# PLANNING COMMISSION AGENDA

## **STAFF REPORT**

**TO:** *Planning Commission*  
**FROM:** *Carla Ahl, Planning Technician*  
**DATE:** *August 17, 2007*  
**RE:** *MOD 07-13 of DR 95-17: Wilson Construction*

# MEMORANDUM

1 PHASE III - SITE PLAN  
 SCALE: 1"=40'-0"

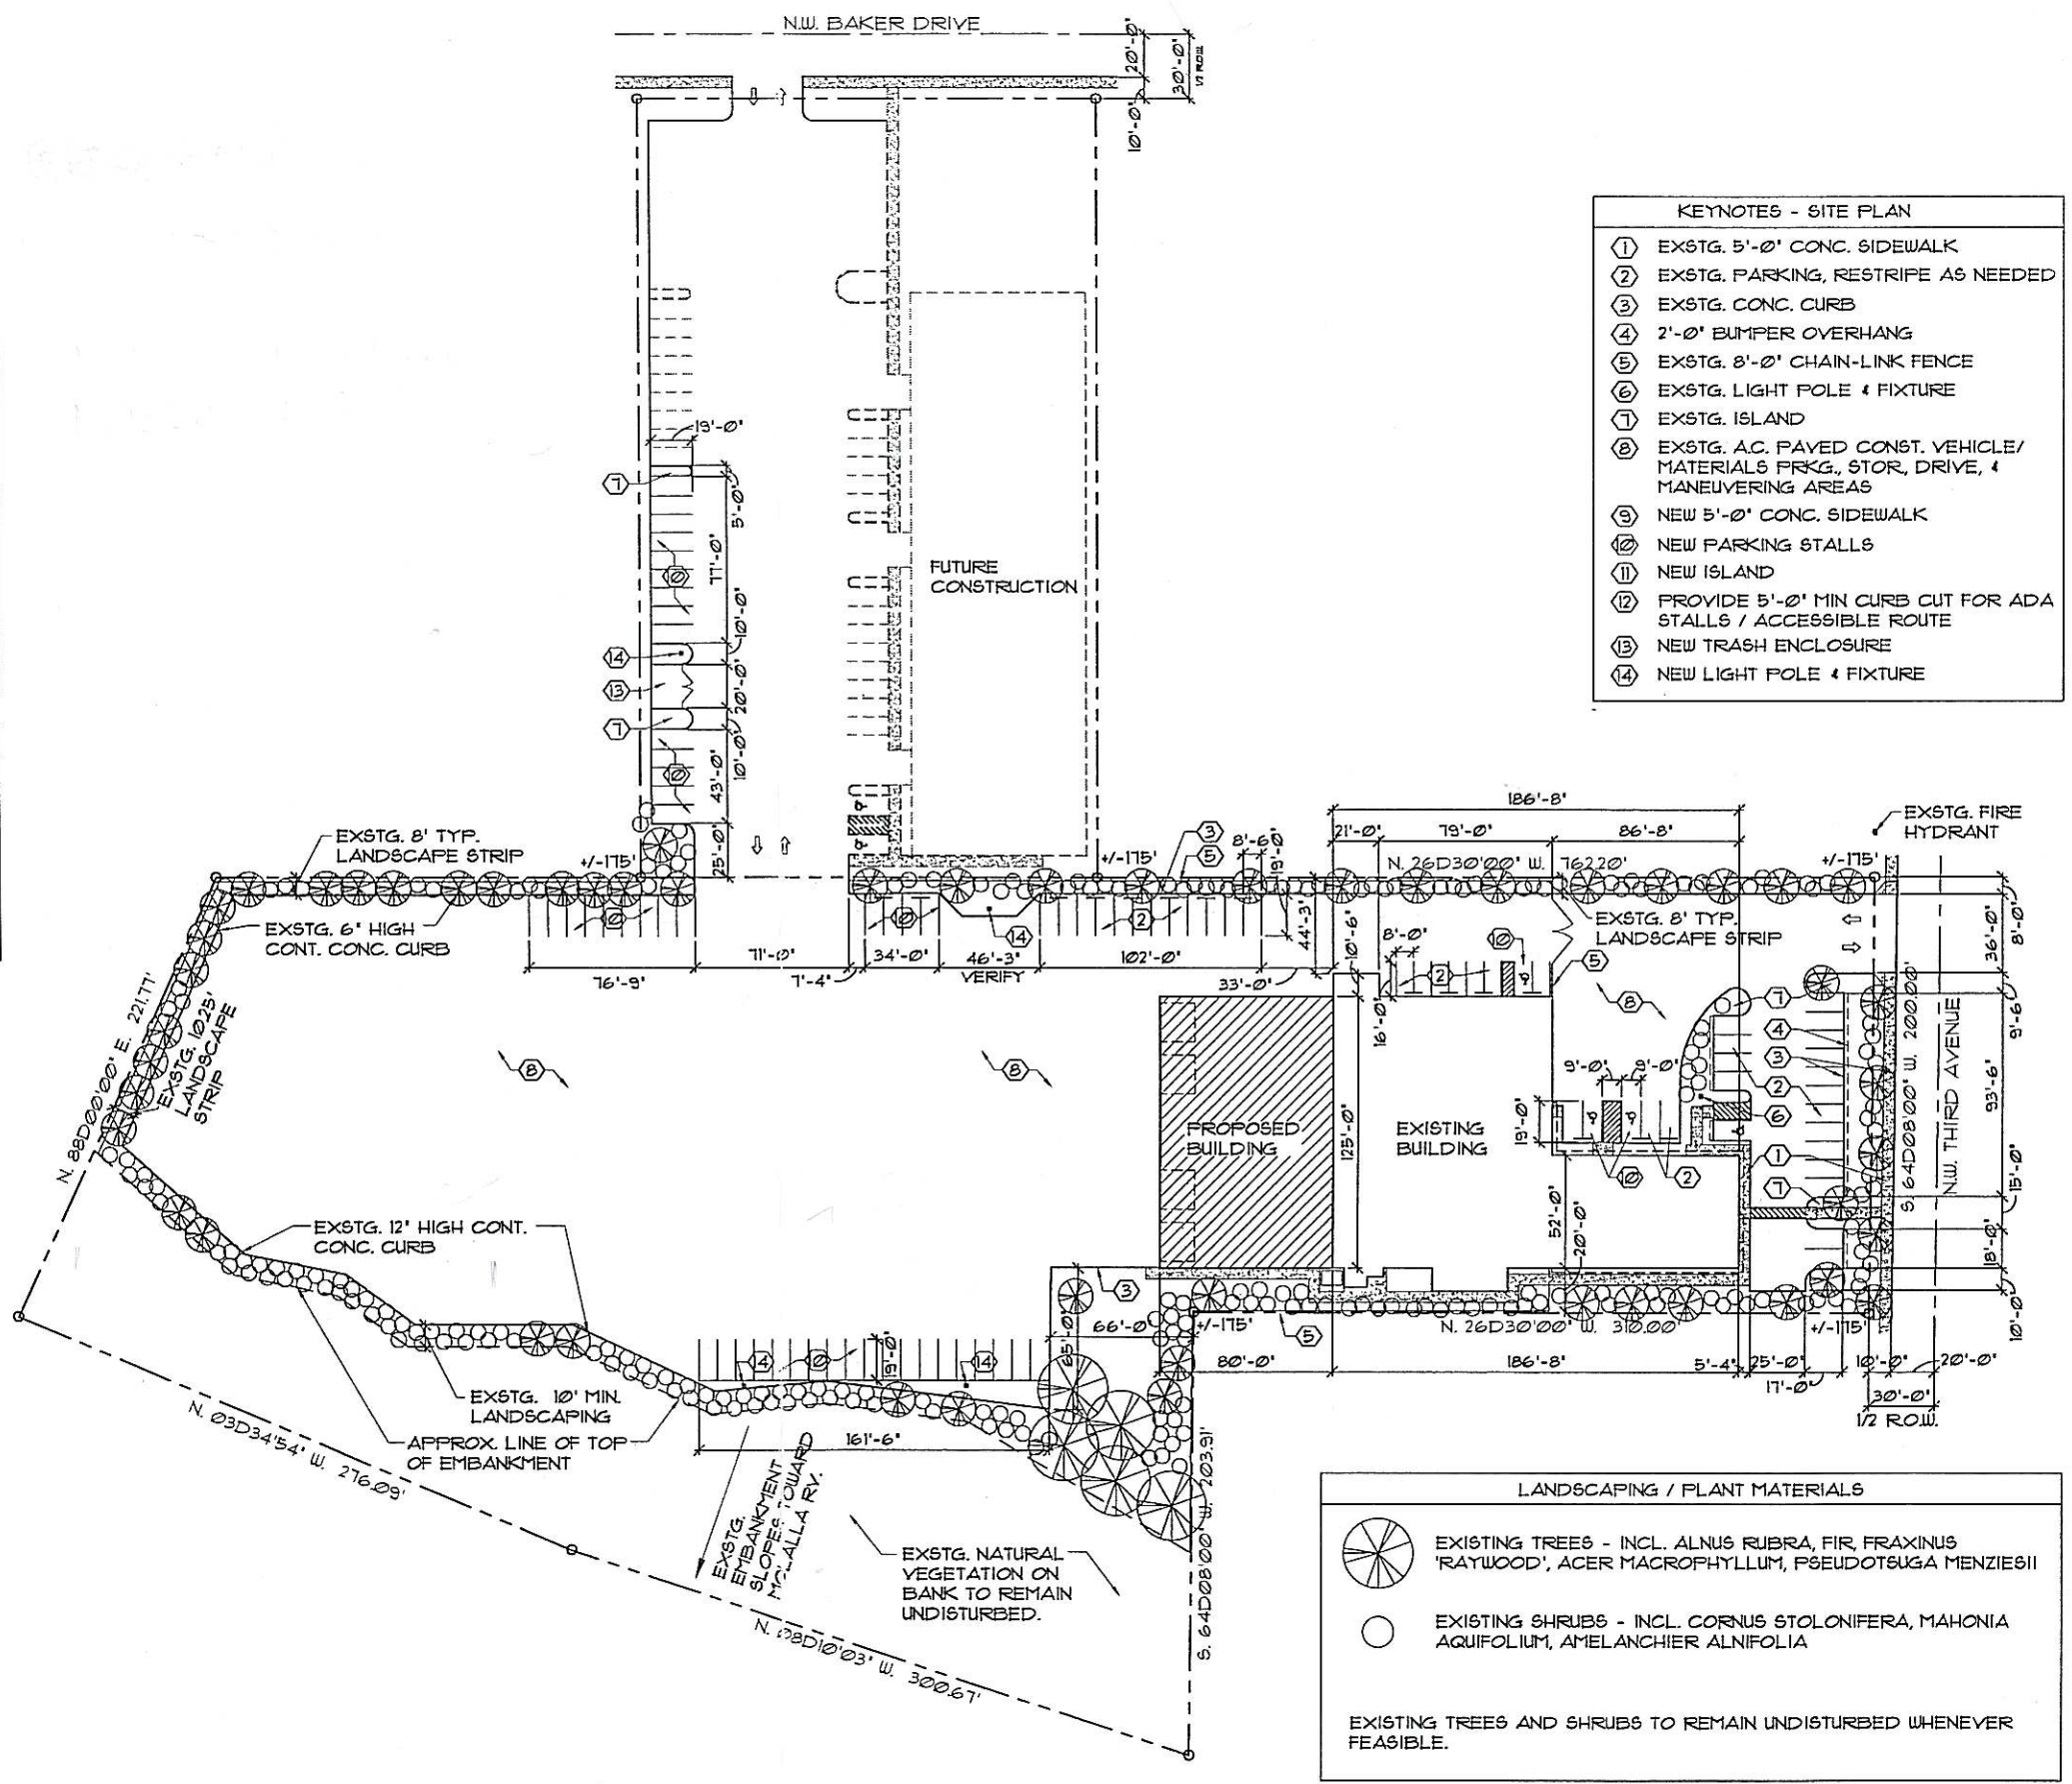
The 10,000 sq ft additional manufacturing space and the reconfiguration of the office space in the existing building increases the required parking by 49 stalls. The applicant has proposed striping the existing asphalt to meet this requirement. Exterior lighting will be required to provide a minimum of 0.5 footcandles with a 4:1 uniformity ratio over the entire site. An illumination plan shall be submitted with the building permit. All site lighting shall be "hooded" or "cutoff" so as not to direct light skyward or towards any public road.

1. A minimum of 81 vehicle parking spaces shall be provided. Wheel stops shall be required in areas where abutting sidewalks are less than 8 feet in width and in areas where landscaping within 2 feet of the curb is not limited to lawn and groundcover or could be damaged by vehicle overhangs. For parking spaces that do not meet the above criteria, wheel stops shall be placed two (2) feet in front of the end of the space.

SHEET:  
 ELEV.

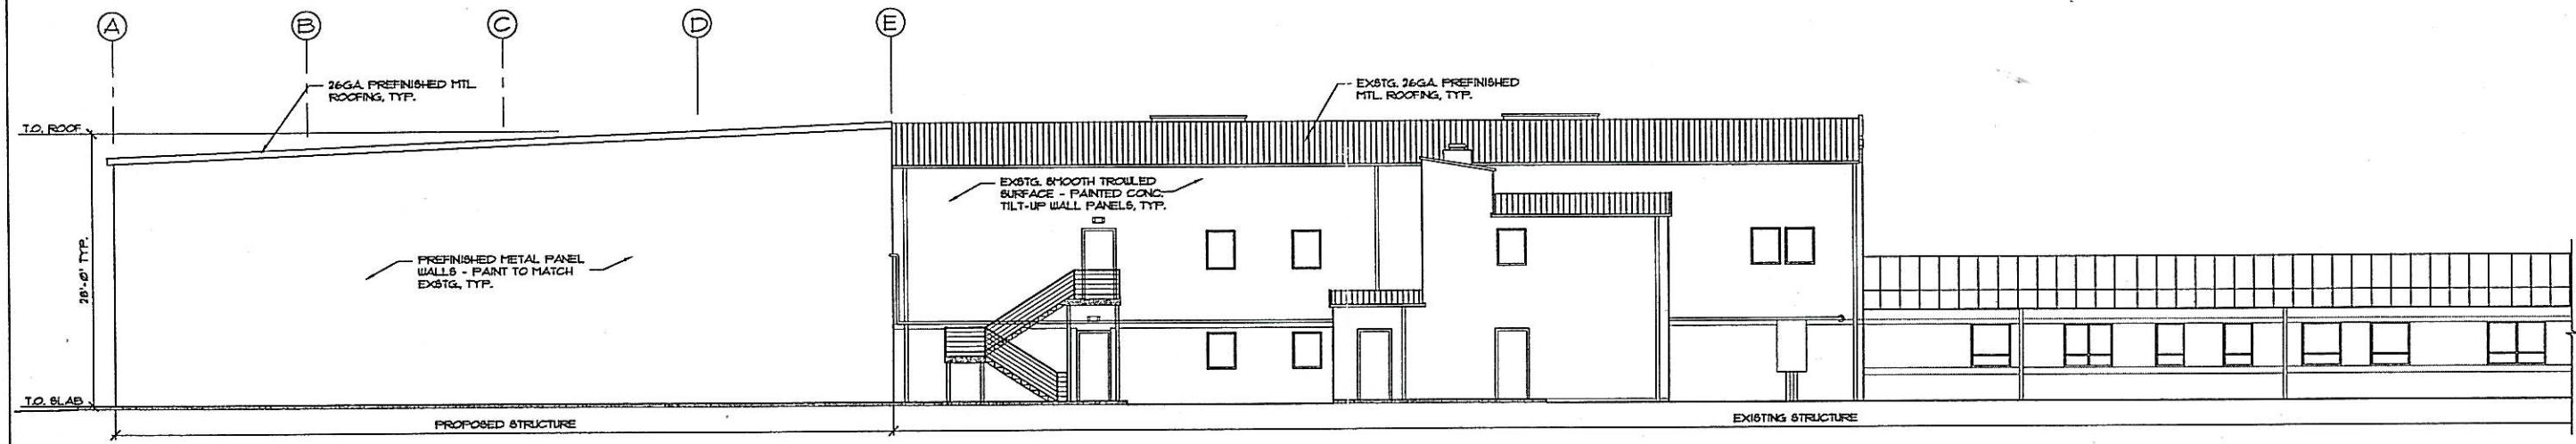
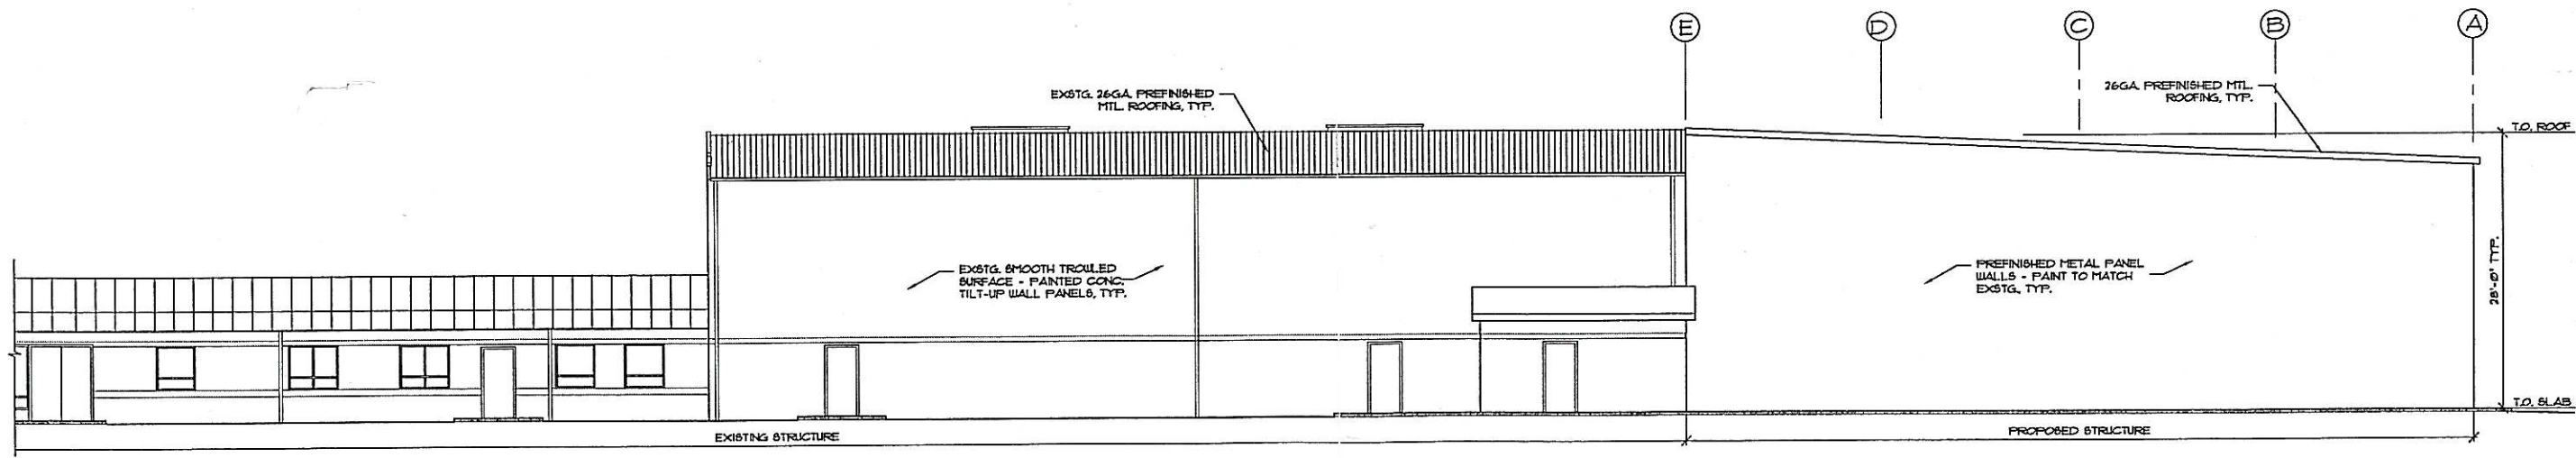
Building elevations are shown on sheet 2. The building is a very straightforward metal building with little ornamentation or detailing, and is 80' by 125'. It has four drive-in bays on the north elevation. While it would not be permitted in the Pioneer Industrial Park, it meets the City's standards this industrial area, as it is compatible with surrounding development. The applicant proposes taupe with blue colors to match their existing building.

8. Unless otherwise approved by the Planning Commission, building colors shall match the existing Wilson Construction building.
9. No signage is proposed in the current application. Any signage to be installed within two years of building occupancy shall be reviewed by the Planning Commission as a new business item.

**A2**

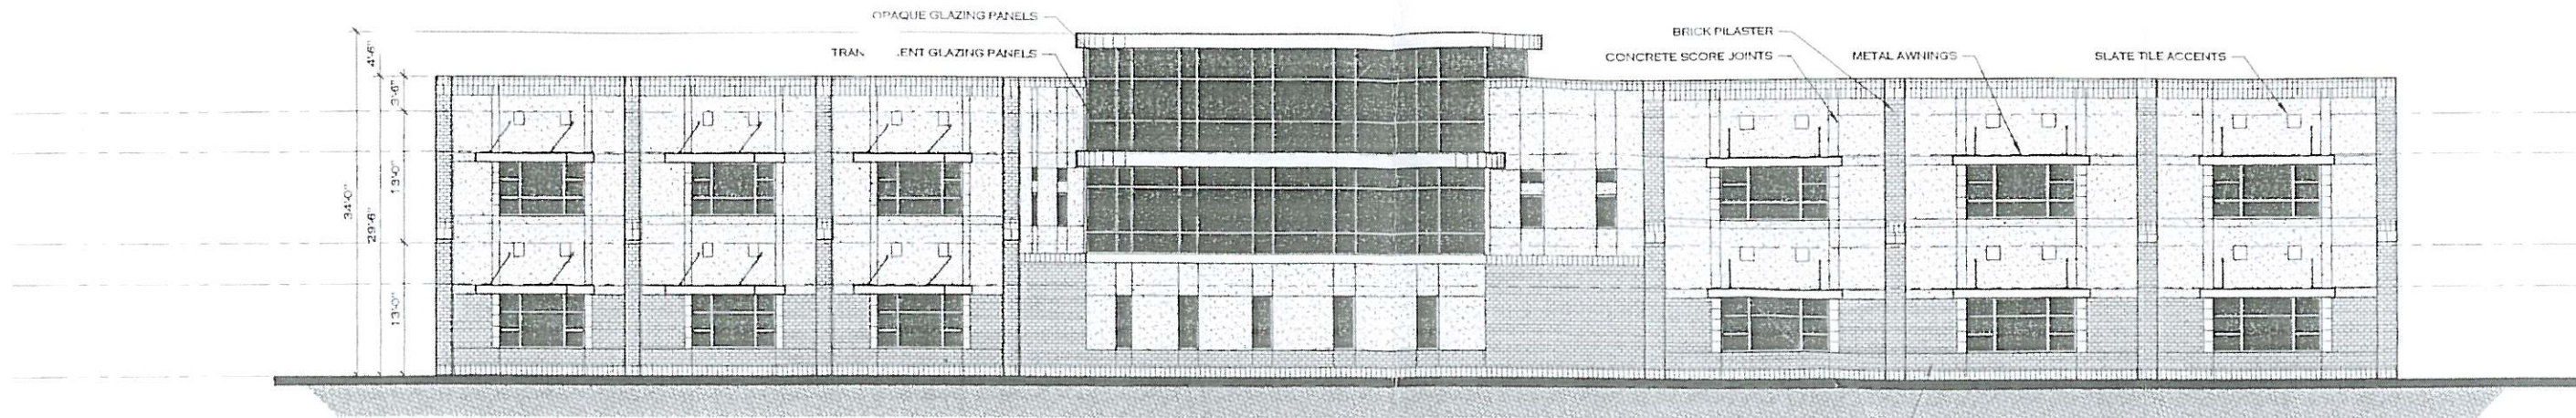
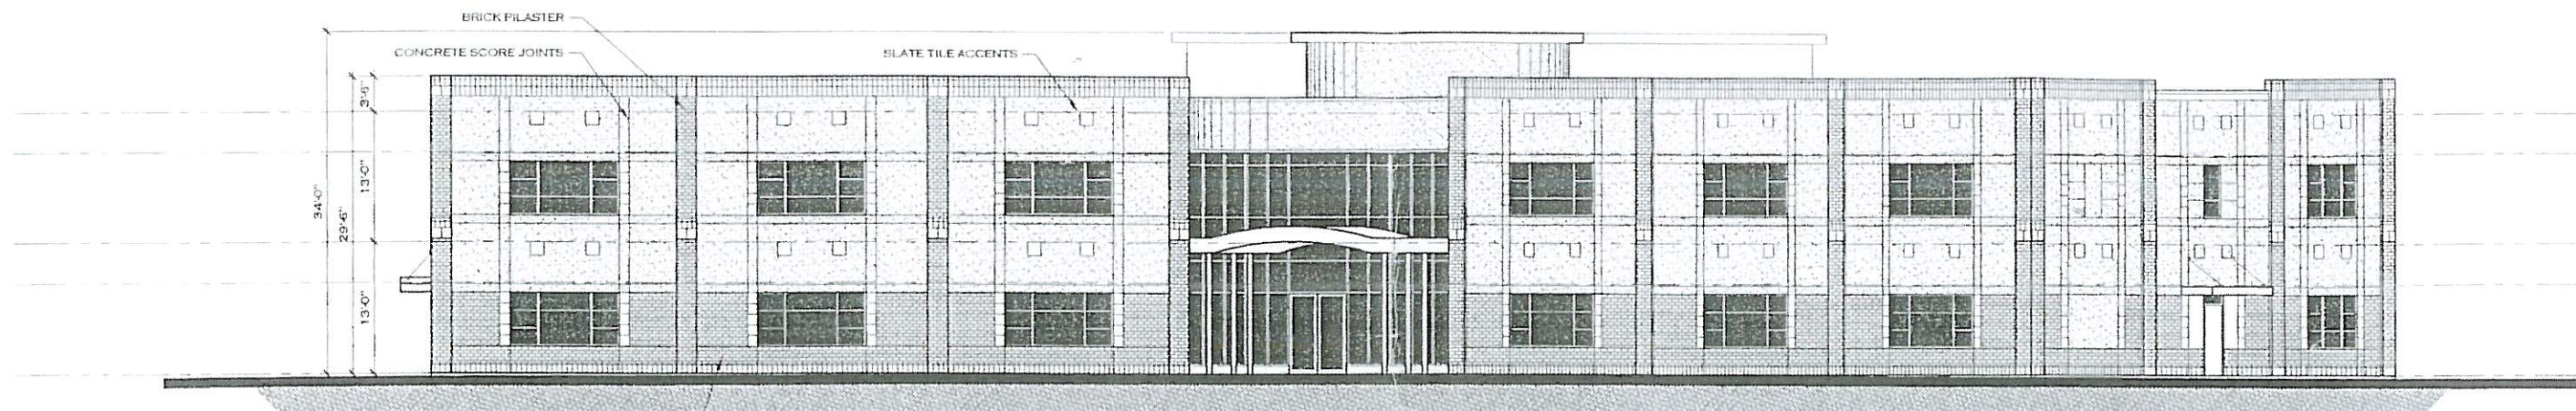
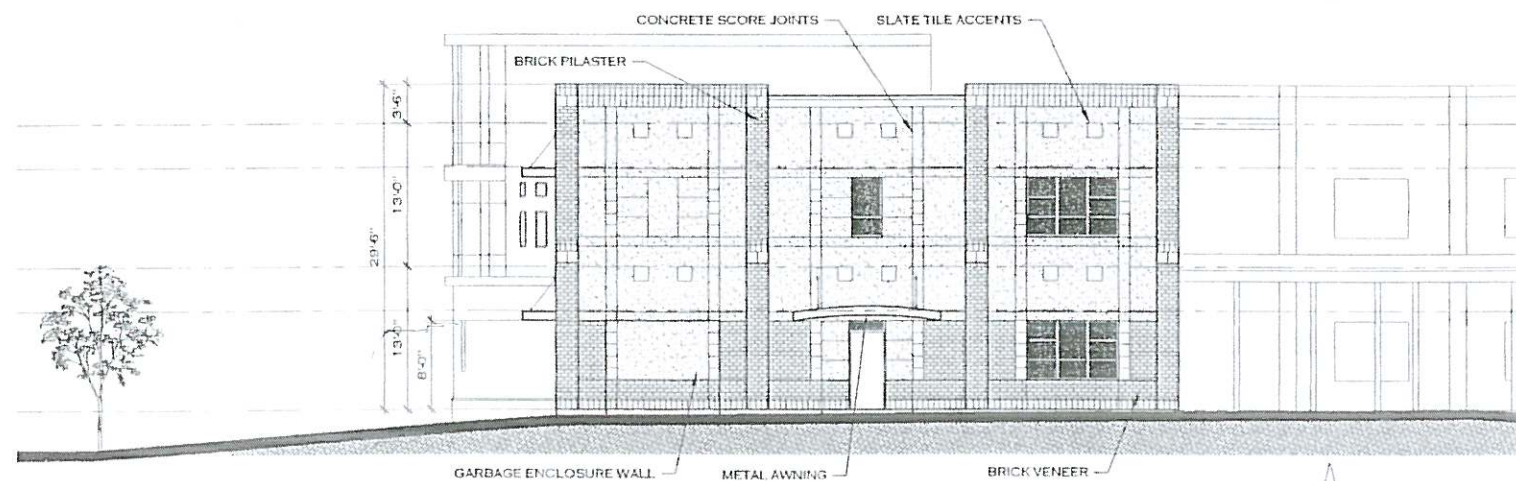
At the Planning Commission's request, we contacted Willamette Falls and asked them to provide a proposal for screening of the large mechanical unit on their roof. Attached you'll find their response. We've scheduled a new business item for the Commission's August 27 meeting to consider their proposal.

I've attached photos of the unit as installed and a copy of the building elevations that were submitted to the Planning Commission for Site and Design Review.

Regarding the Mechanical Unit on the roof of the building, the ownership group is aware of the presence of the unit and feels that this type of equipment goes hand in hand with a new building of this type. We have conducted an informal survey of incoming patients to the new facility asking if they have any concerns regarding the new facility, and to date not one person has mentioned the roof top unit. In an effort to address the concerns you cited in your June 12, 2007 Memorandum, the ownership group proposes that the unit be painted a color that is complimentary to the color of the main body paint color used on the exterior of the new building. This will not hide the unit (nothing will completely hide a unit of this size), but will help the unit to better blend in with the balance of the new facility. We have explored the option of adding additional screening to the unit, but feel that all this really does is add to the size and height of the unit, rather than hiding it. I have attached a picture from another recently completed building with a similar type unit showing the effect of painting the unit to better match the main exterior colors.

In summary, the building owners request that you please consider our proposed solution to paint the existing unit in a color complementary to the main color used on the exterior of the new building.
